From: David Hugh-Jones [david@oysters.co.uk]
Sent: 26 October 2009 16:42
To: Sonja Smith
Subject: Submission re WWDL D0056-01 Midleton WWTP (1)
Attachments: 091026 EPA WWDL.doc; Image0001.JPG; Image0002.JPG; Image0003.JPG; Image0004.JPG; Image0005.JPG; Image0006.JPG; Image0007.JPG; Image0008.JPG; Image0009.JPG; Image0010.JPG

Application by Cork County Council for a Waste Water Discharge Licence for Middleton WWTP, Co. Cork : D0056-01.

BAILICK 2 SUBMERSIBLE PUMPING STATION TO SHOW LEVEL OF GRAVITY OVERFLOW OPE

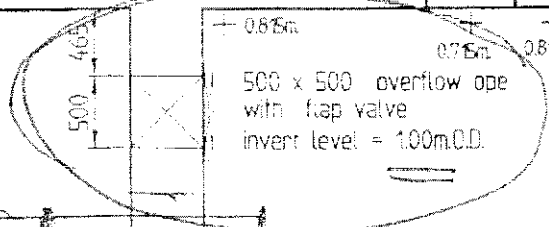
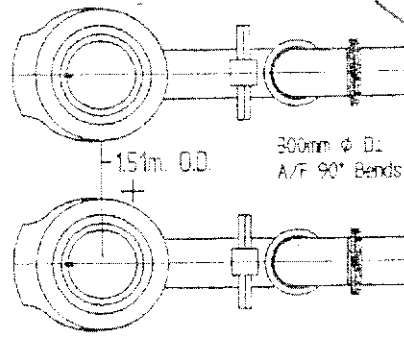
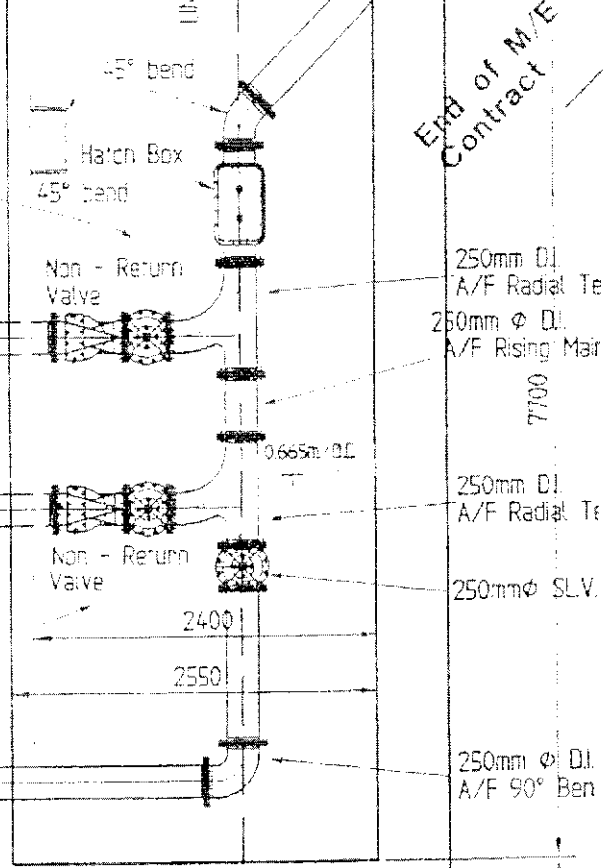
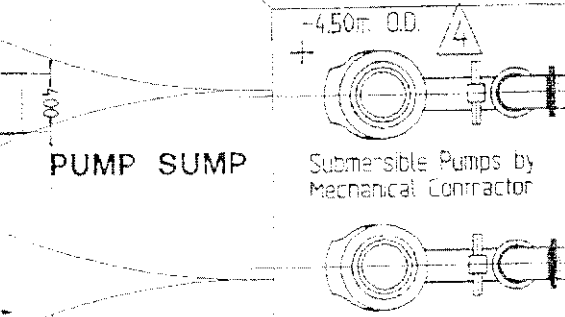
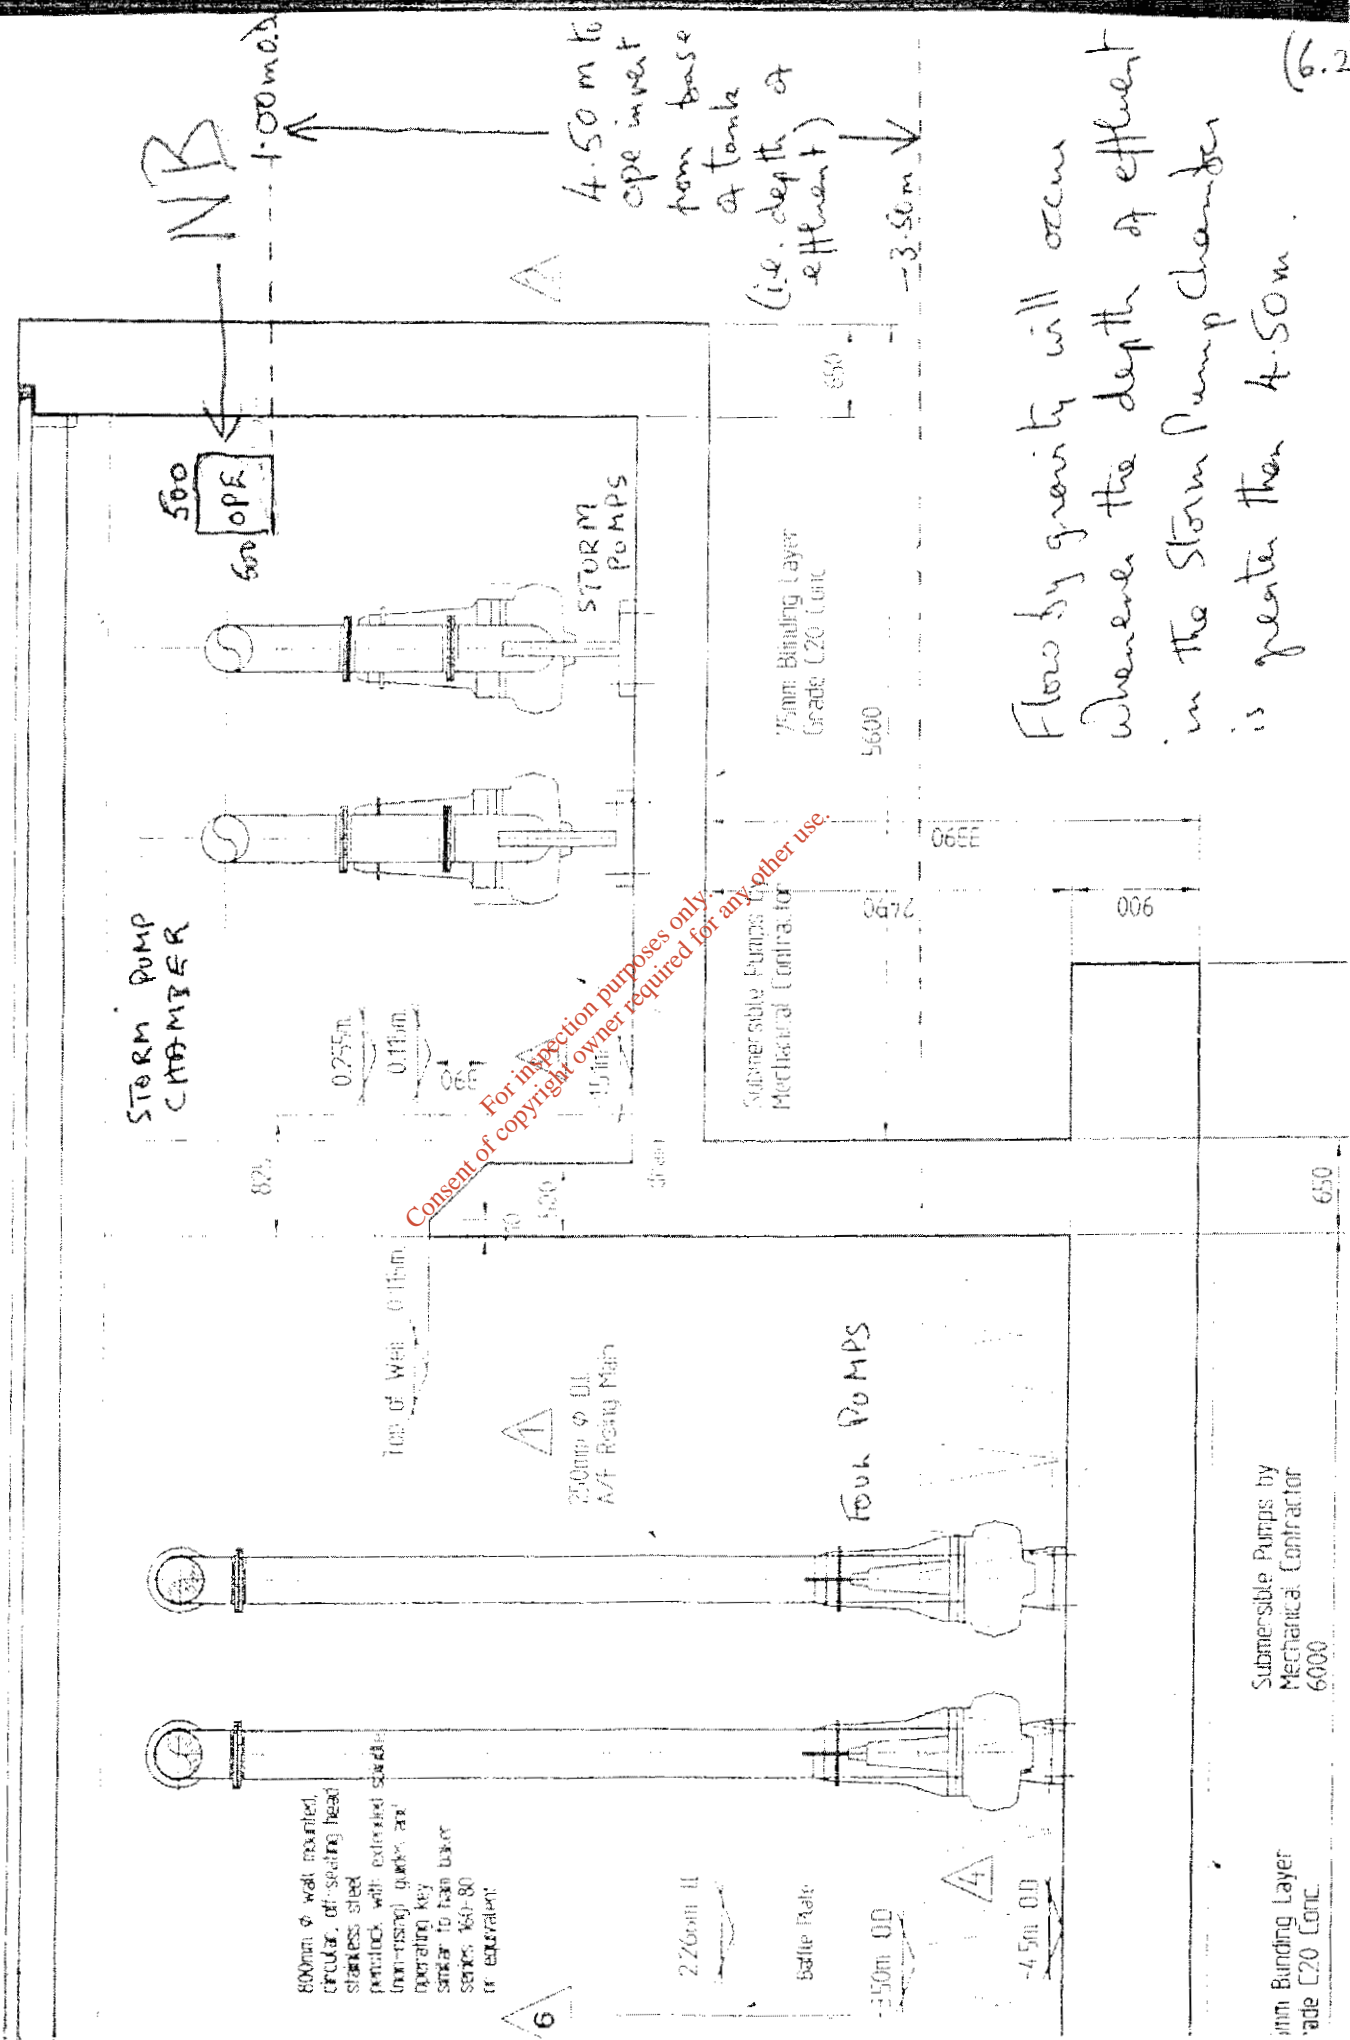
I enclose parts of Drawing 122 Rev.6 (**6.1, 6.2**), from which you will see that the overflow ope in the storm pump chamber is set at 1.00m and the bottom of the storm cells is at -3.50m, so that the invert of the overflow ope is reached when the depth of effluent in the cells is 4.50m and the 500 x 500mm ope is flowing full when the effluent depth is 5.00m.

Flow by gravity will occur whenever the depth of effluent in the Storm Pump Chamber is greater than 4.50m. (6.2)

Bailick 2 Storm Pump Chamber Level 1

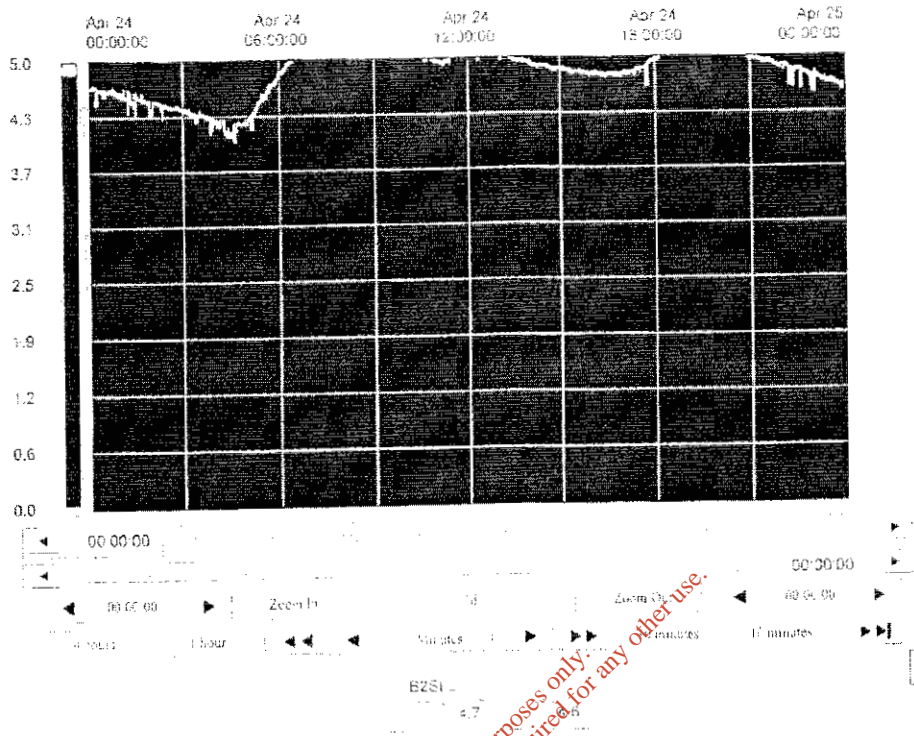
However, take the instantaneous data for April 24th (7). The ope is flowing full for 10 hours and half-full for 6 hours. This flow is in addition to the storm pumps, which, in fact only record 43m³ that day. There is no other way for it to have gone except by gravity.

43m³ overflows recorded by the storm pumps
